## GLPC AGENDA ITEM # 12

### Planned Development approval by True North Companies File #: VA-2022-20

## **Twenty3Twenty Planned Development Narrative**

TWENTY3TWENTY - NORTH PATTERSON  
COMMERCIAL OUTPARCEL EXHIBIT

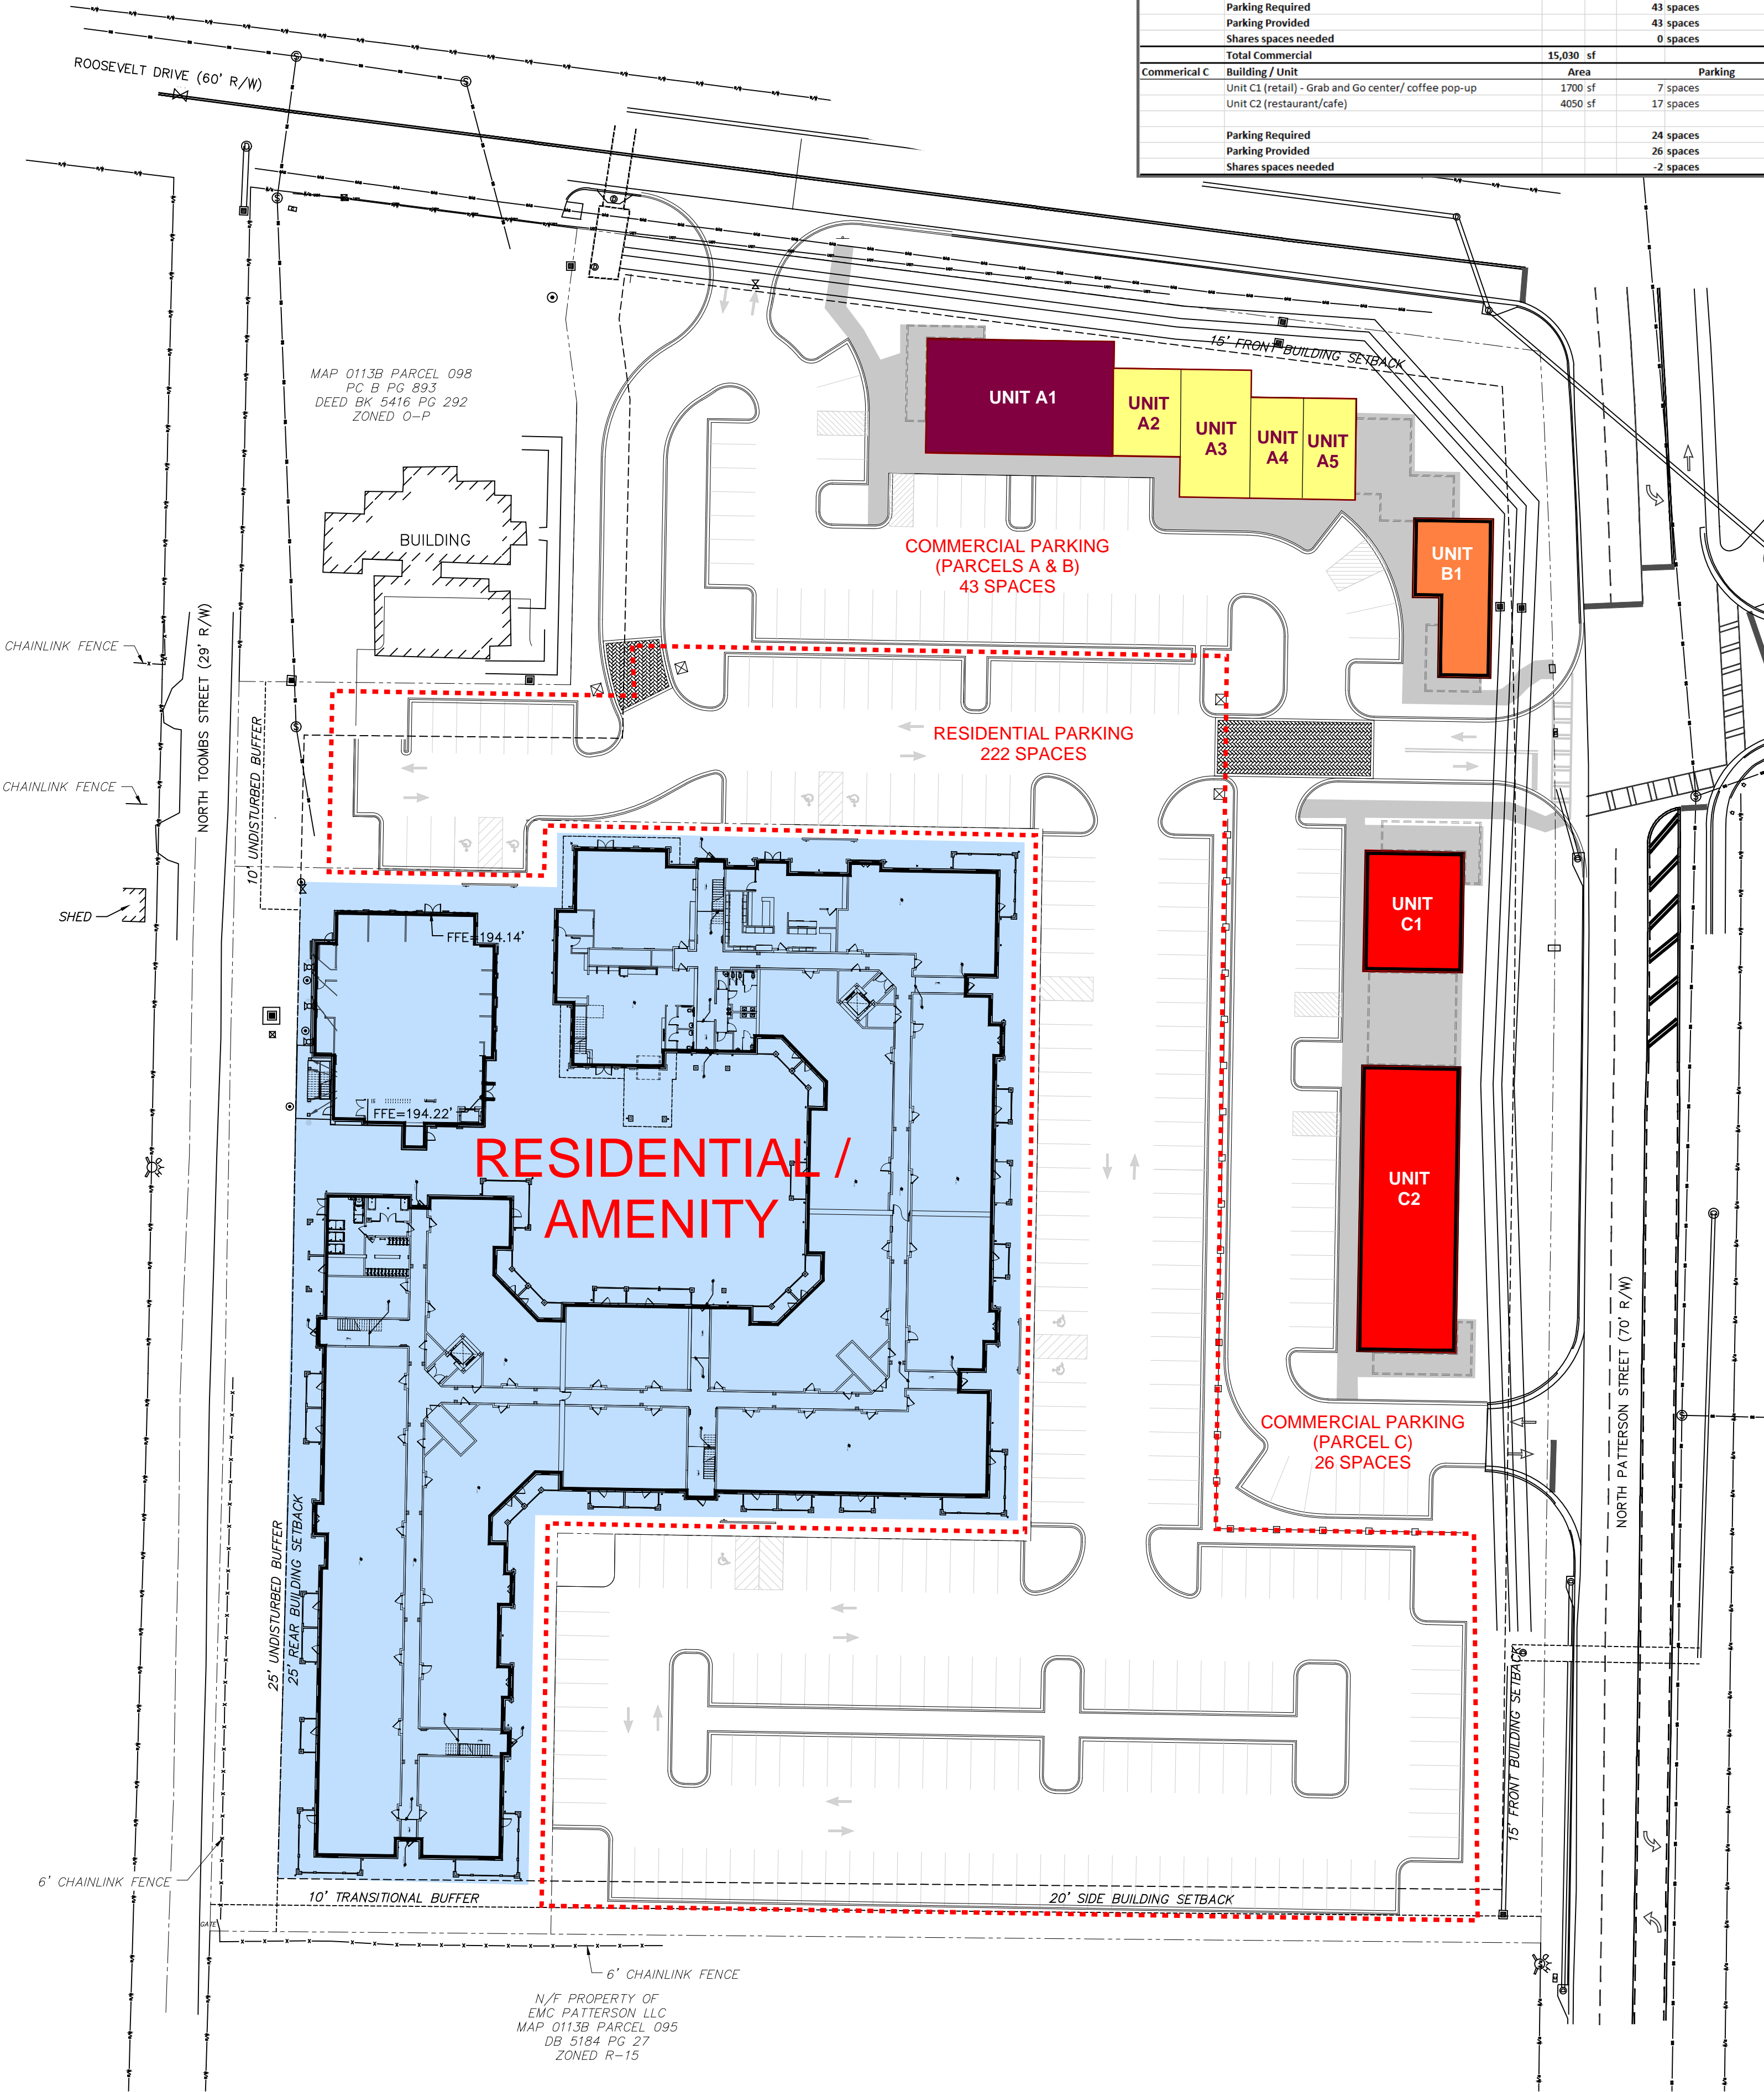
- (1) Clarify internal intersection traffic flow.
- (2) Clarify trash management – for both residential and commercial areas.
- (3) Verify Fire Dept access and that there are no issues for the development design as shown.
- (4) Confirm GDOT approval of driveway design configuration onto Patterson
